SRR-CWDA-2019-00101

**ACTION ITEM FOLLOW-UP IN SUPPORT OF U.S. NUCLEAR REGULATORY
COMMISSION F AND H AREA TANK FARMS AND SALT WASTE DISPOSAL
MONITORING ACTIVITIES**

Figure 15. East-west cross-section of GSA2018.LW model through F-Area;
vectors are fixed length showing flow direction only.

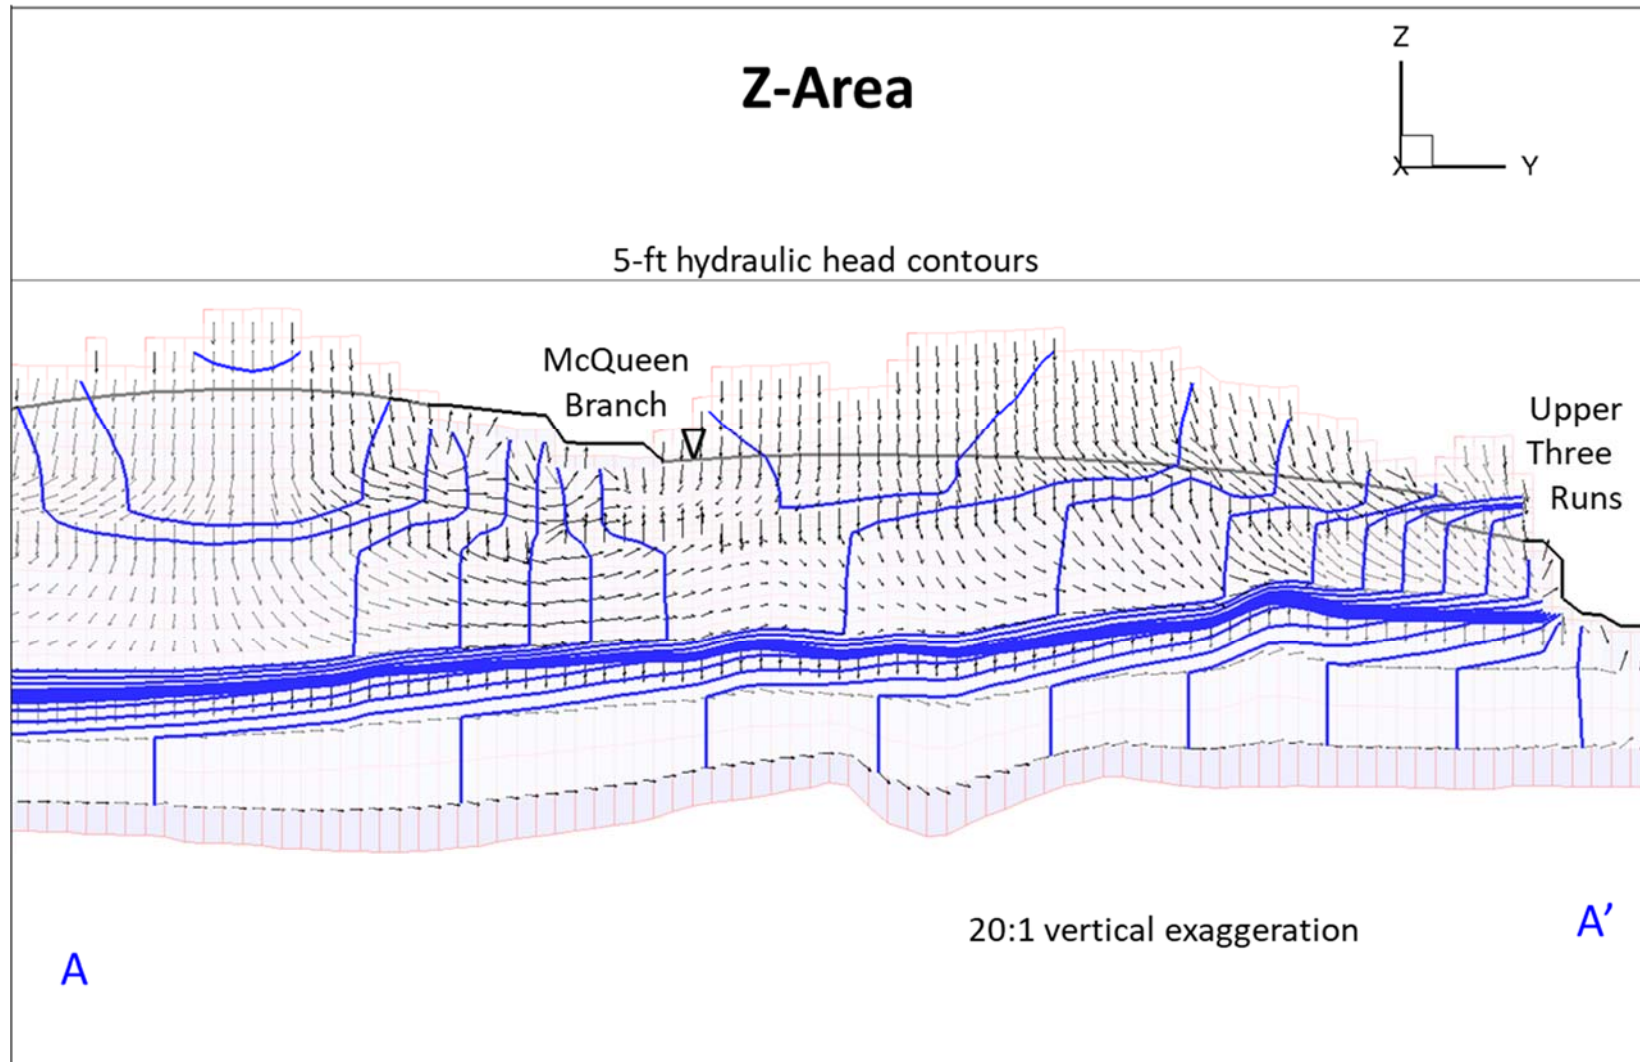
NRC # TFS-CY19-01-011 (Action Item 11 from 3/2019 OOV) and NRC # SDF-CY16-01-013 (Action Item #13 from 4/2016 OOV)

Figures 7 and 8 provide a cross-section of the GSA2018.LW velocity field through E-Area comparable to Figure 2-8 in WSRC-TR-2004-00106 (Reference 4). In addition, Figures 9 through 14 provide similar cross-sections for F-, H- and Z-Areas. Figures 15 through 20 provide cross-sections in the east-west direction for F-, H- and Z-Areas.
